ECE/TRANS/WP.29/GRSG/2007/8/Rev.1
1 October 2007

Regulation No. 107

Provisions for driver's workplace

Proposal for amendments to Regulation No. 107

"Figure 31

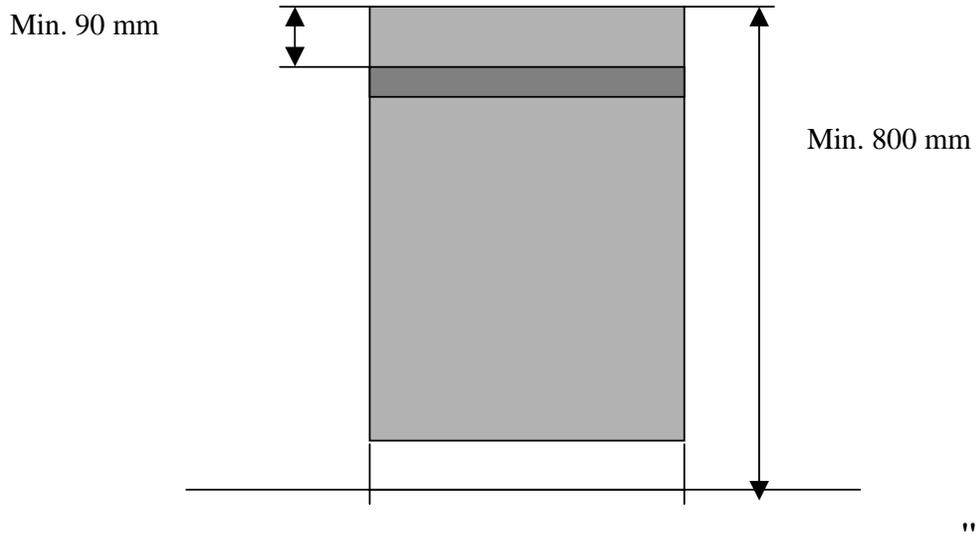
7.7.13.1.1. The height of the partition or barrier shall equal at least 800 mm measured from the floor of the passenger compartment (see annex 4, figure 31).

7.7.13.1.3. The distance between the uppermost edge of an area destined to hold any object, e.g. tables, etc. and the uppermost edge of a partition or barrier shall be at least 90 mm (see annex 4, figure 31).

Annex 4., insert a new the following new figure 31:
